City Council
Agenda Memo

SUBJECT: Appeal of a denial of a sidewalk waiver for property located at 6449 Buffalo Gap Road.

**Re: Hamil Family Funeral Home Building and Parking Expansion
6449 Buffalo Gap Road, Abilene, Texas 79606
Request for Waiver of Specific City Site Plan Requirements**

Re: Sidewalk Waiver Request for Hamil Family Funeral Home at 6449 Buffalo Gap Road.

Exhibit A – Photographs of Existing Construction

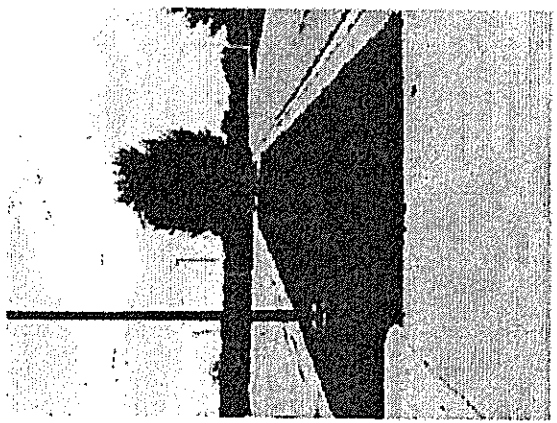
There are two specific existing conditions at the site which will make the installation of sidewalks along Champions Drive extremely impractical. Refer to the photographs attached as Exhibit "A".

1. Existing Obstructions. The Champions Drive Right-of-Way is 60 feet wide with 40 feet of road paving and 10 feet of parkway space on either side of the road. Including the 10 foot parkway width, the total distance between the back of curb along Champions Drive to the back of curb in the parking area is 16 feet. As can be seen in the photographs, the parkway is lined with trees (11 total trees spaced at approximately 23 feet on centers). The trunks of these trees average 4 to 5 inches in diameter and are located approximately 6 feet from the back of the curb along Champions Drive with drip lines extending approximately 3 feet out from each tree trunk. Due to the positioning of the trees, it is not possible to locate the required sidewalk at the right-of-way line per the City Design Standards without relocating these trees, which could potentially damage or kill the trees in the process. Other obstructions in the 16-foot space in between the parking area and the roadway include several light poles (located on both sides of the row of trees) and an existing sanitary sewer collection line running parallel with Champions Drive approximately 4 feet behind the road curb.

2. Existing Concrete Entrance Drives. The most severe obstacles to sidewalk construction are the two existing 30-foot wide concrete entrance driveways. These two entrance drives were constructed as part of the original 2004 project and were approved by the City at that time. As-built, the western drive is sloped at approximately 8.20 percent while the eastern drive is sloped at approximately 4.90 percent. Both driveways greatly exceed the maximum 2.0 percent cross slope allowed by ADA/TAS rules and regulations for accessible travel routes. In order to build a sidewalk that is compliant with all ADA/TAS requirements, the existing entrance drives will have to be demolished, removed and re-built with a section appropriately sloped to accommodate a sidewalk crossing. While the eastern drive could potentially be re-built within the confines of the 10-foot parkway space to meet both ADA/TAS and the City requirements for cross slope, re-constructing the western drive will create additional problems. In order to meet all cross slope requirements, the existing 10-foot drive will either have to be lengthened or lowered at the property line where it currently terminates into the asphalt parking area. Lengthening or lowering the drive will likely require a portion of the existing asphalt paving in the parking lot to be removed, the subgrade soils to be re-graded and compacted, and re-paved in order to preserve smooth transitions between the entrance drive and parking area. Lowering the drives could also potentially affect the established site drainage patterns and create flow paths that would allow storm water to discharge un-mitigated from the site instead of draining into the detention pond as required by the approved drainage plan.

Existing trees and light poles cited do not constitute a sufficient barrier prohibiting the required sidewalks. Similarly, the existing mailbox by itself is insufficient to warrant complete elimination of the requirement when balanced against the public health and safety benefits of sidewalks. City standards provide flexibility to relocate sidewalks on a site when potential barriers exist within the right-of-way. A sidewalk could be located within the landscape area adjacent to or near the curb of the parking lot.
